SUBJECT **Response to Comments and Work Plan Addendum**
Exterior Additional Soil and Soil Vapor Assessment Work Plan
Dry Clean 580 and Adjacent Retail Units
3735 East Castro Valley Boulevard
Alameda County LOP No. RO 3097

SUBJECT Response to Comments and Work Plan Addendum
Exterior Additional Soil and Soil Vapor Assessment Work Plan
Dry Clean 580 and Adjacent Retail Units
3735 East Castro Valley Boulevard
Alameda County LOP No. RO 3097

PROPOSED ADDITIONAL SOIL VAPOR POINTS
 DRYCLEAN 580
 3735 E. CASTRO VALLEY BOULEVARD
 CASTRO VALLEY, CA

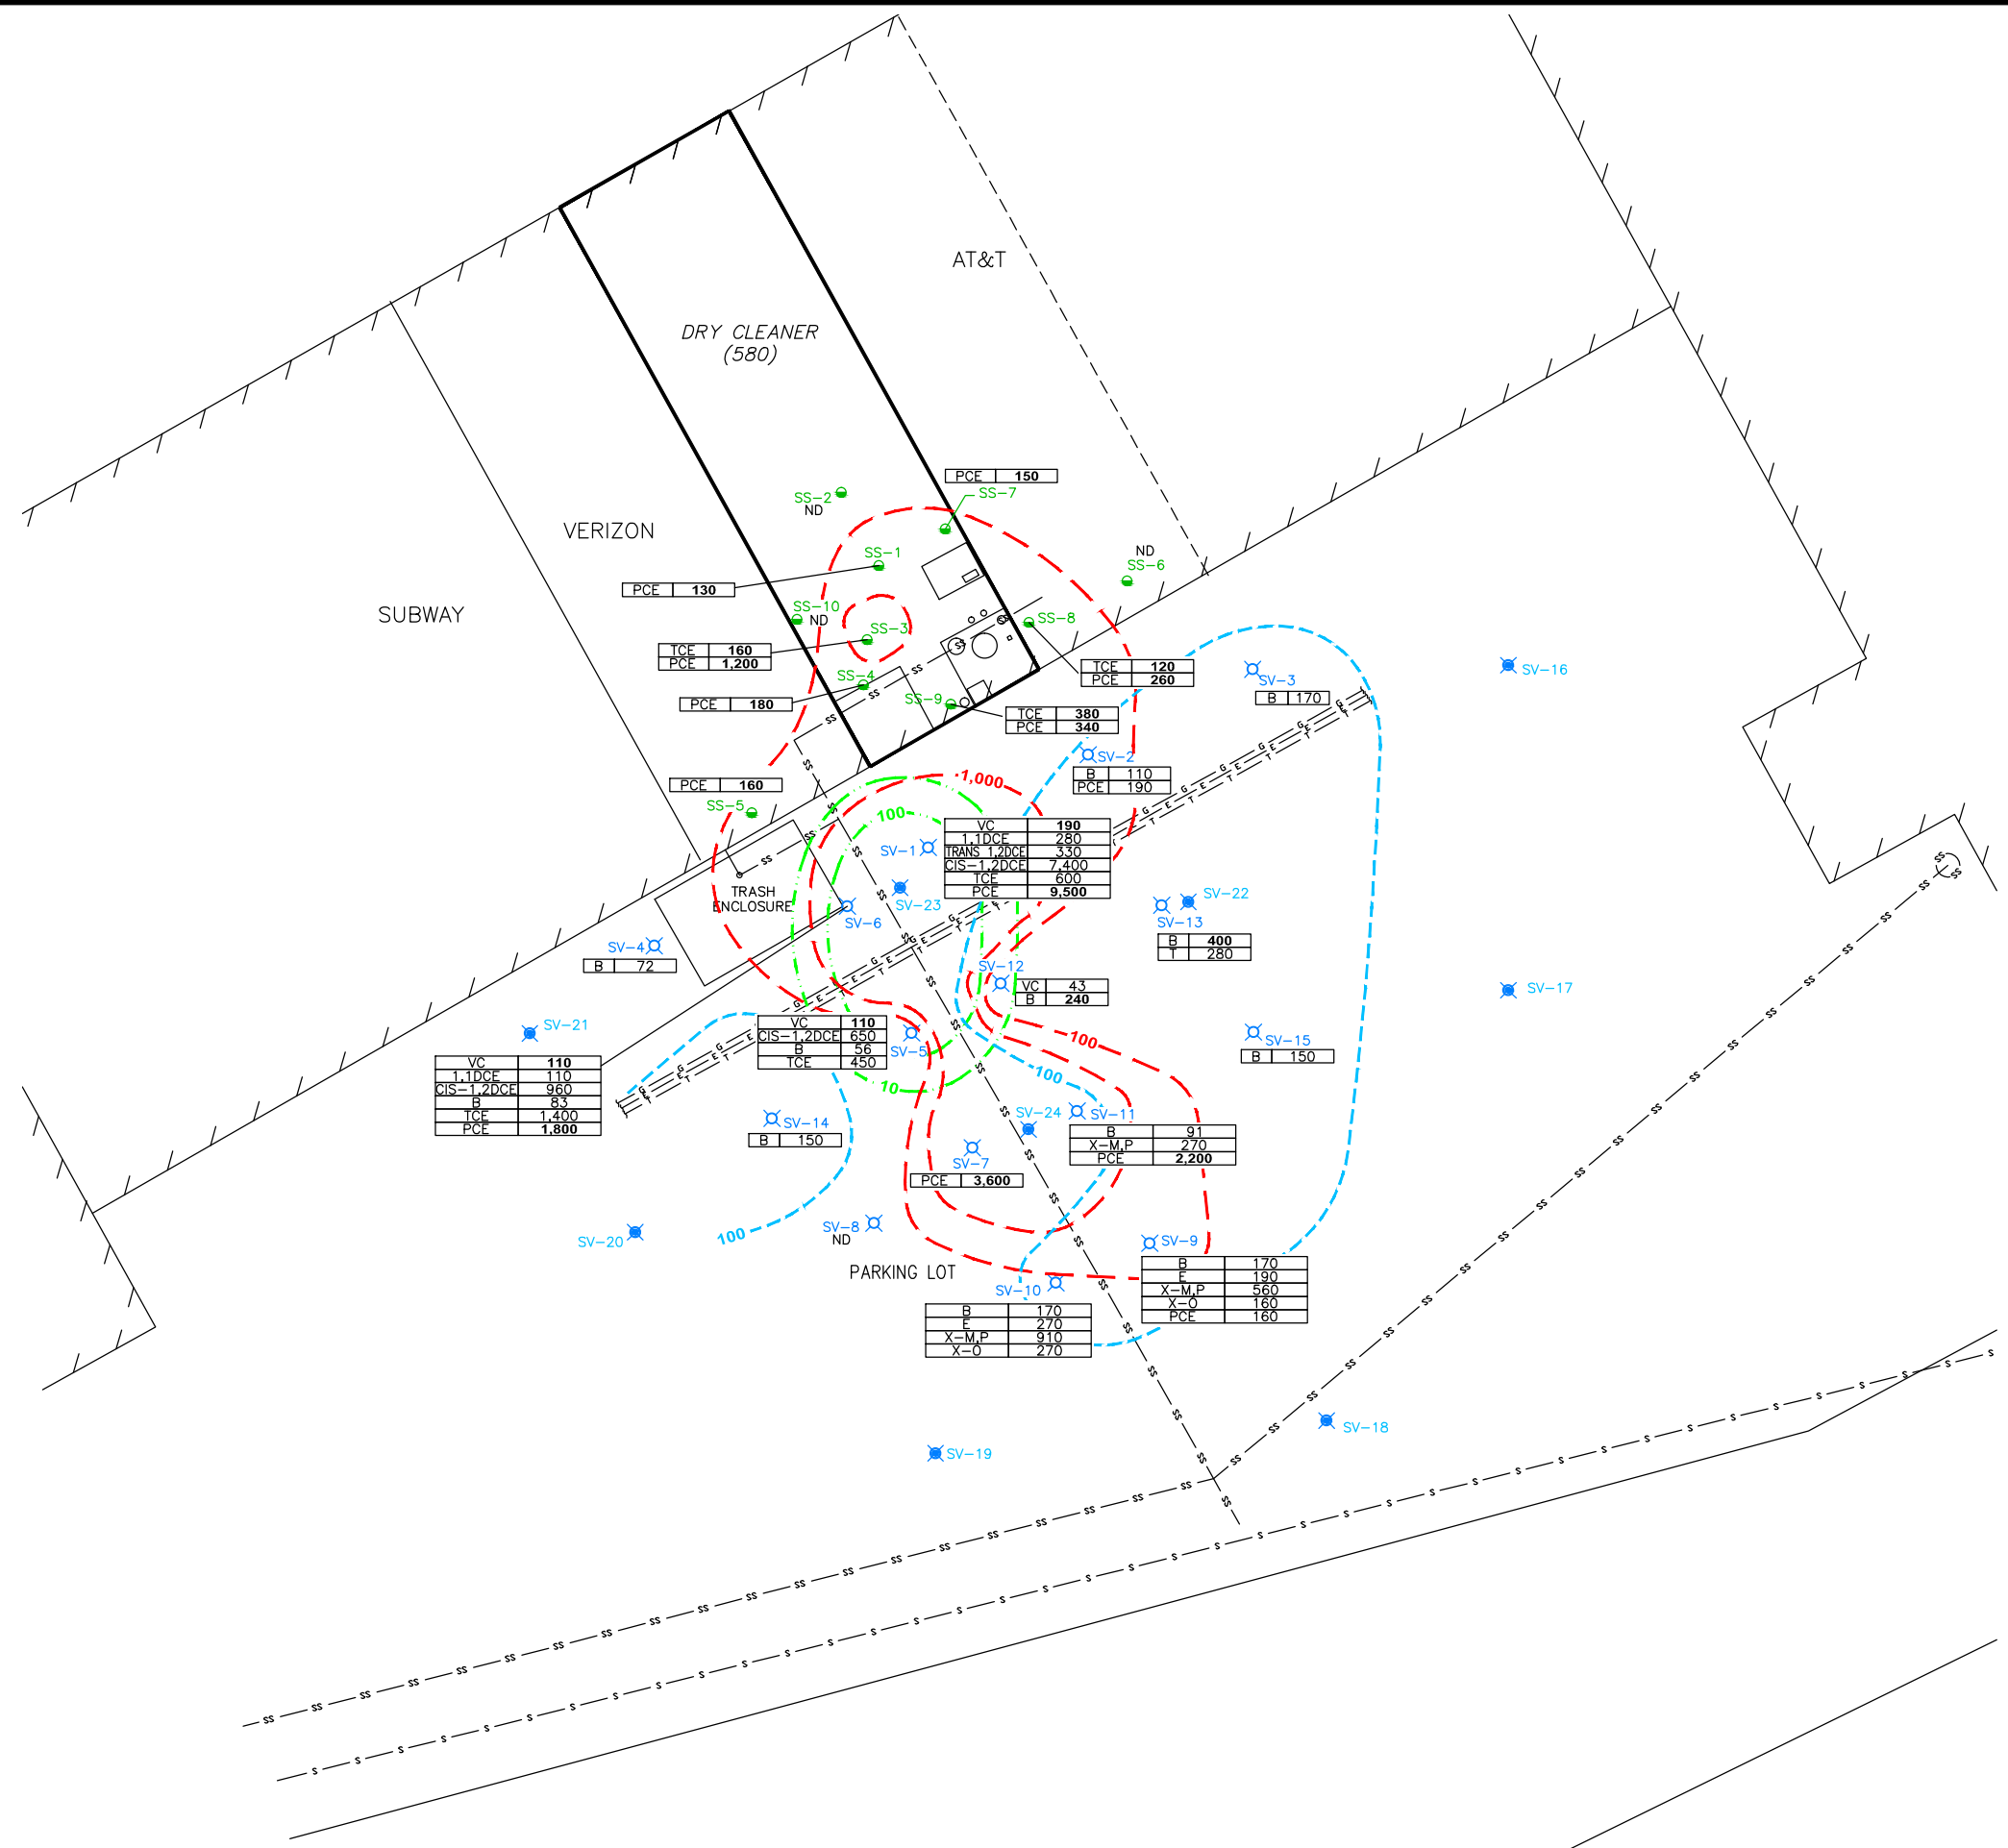
Comment 1: Provide Rationale for Placement of Additional Dual-Completion Soil Vapor Sampling Wells

1. Rationale for the placement of the 7 soil vapor sampling wells. 6 of the 7 proposed locations are on the perimeter of the vapor plume and therefore it appears the rationale is to define the lateral extent of the plume. Only 1 of the proposed locations (SV-22) is adjacent to a previous sample point (SV-13) with high concentrations of benzene. It is not clear to us why there are not more dual depth probes located in other areas with concentrations have been detected at previous sampling points above screening levels of PCE (SV-1, SV-6, SV-7, SV-11), TCE (SV-1, SV-5, SV-6) and benzene (SV-12, SV-13). It seems logical to us that one of the purposes of collection of additional soil gas samples at two depths is to help identify source areas in addition to collecting data on attenuation.

The scope of work proposed in the Work Plan was developed in response to Item 2 in ACEH's electronic correspondence dated September 30, 2014 (Appendix A), and subsequent verbal communications. The discussion presented in Item 2 concerns the potential source and extent of the petroleum hydrocarbon (predominantly benzene), and the potential impact to reductive dechlorination of the halogenated volatile organic compounds (HVOCs). The locations of soil vapor sampling wells (SVS) wells SV-16 through SV-

21 (Figure 2) were selected to delineate the lateral extent of the vapor-phase benzene, and to determine a potential source of benzene based on concentration gradients. The location of SVS well SV-22 was selected to evaluate the vertical extent of vapor-phase benzene in the area with highest previously reported concentration. The distribution of reported vapor-phase HVOCs and benzene concentrations overlap but are not coincident.

After discussion with ACEH, Cardno ATC concurs that vertical assessment within the laterally defined HVOC area will be beneficial and may provide useful data for remediation, if warranted. In addition, installation of the additional SVS wells will be most cost-efficient if done during the same mobilization as the vapor-phase benzene assessment. We therefore propose two additional dual-completion SVS wells at the locations shown on Figure 2. Well SV-23 will be installed midway between SV-1 and SV-6. Well SV-24 will be installed midway between wells SV-7 and SV-11. These locations coincide with the approximate areas of highest concentrations of vapor-phase perchloroethylene and vinyl chloride, and will provide data regarding the vertical concentration profiles, attenuation, and natural bioremediation potential.

The two additional dual-phase SVS wells will be drilled, constructed and sampled pursuant to the methods described in the original Work Plan.
